TECHNICAL BULLETIN
021
January 2018

BACKUP RING PXI VAM 9.850-265.0 (old 000905)

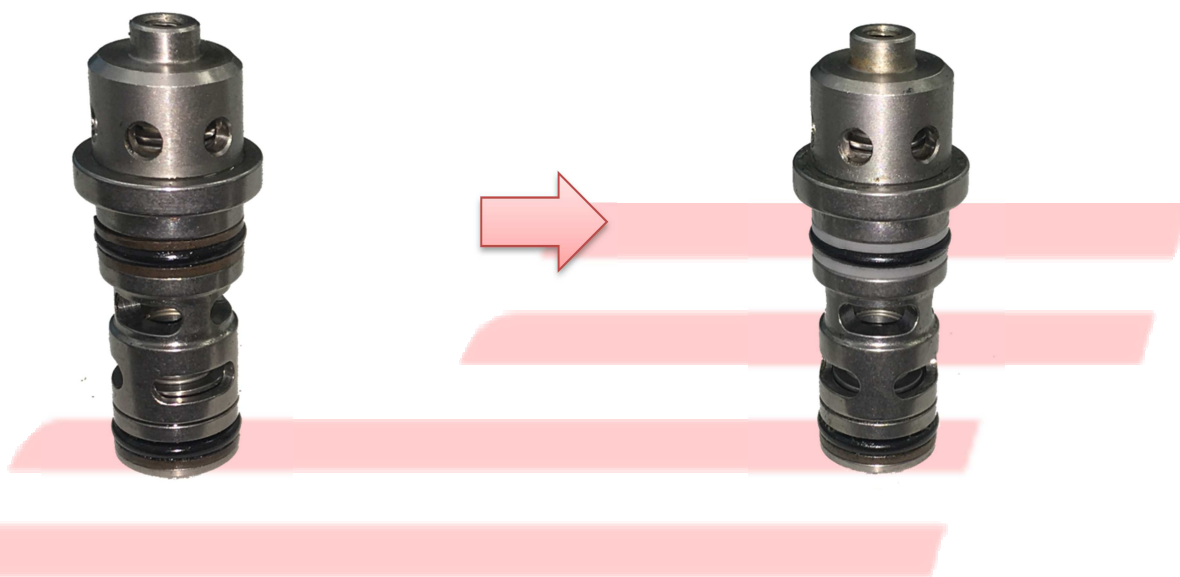
- *Modification of material on 2 backup rings 9.850-265.0 placed in the VAM center cartridge 1.099-704.0 (old 360407) and 1.099-703.0 (old 360406) of the PXI pumps;*
- *This new material improves significantly the durability of the O-ring between the 2 backup rings; visually the new backup ring is white*
- *The new backup ring is interchangeable with the previous one.*
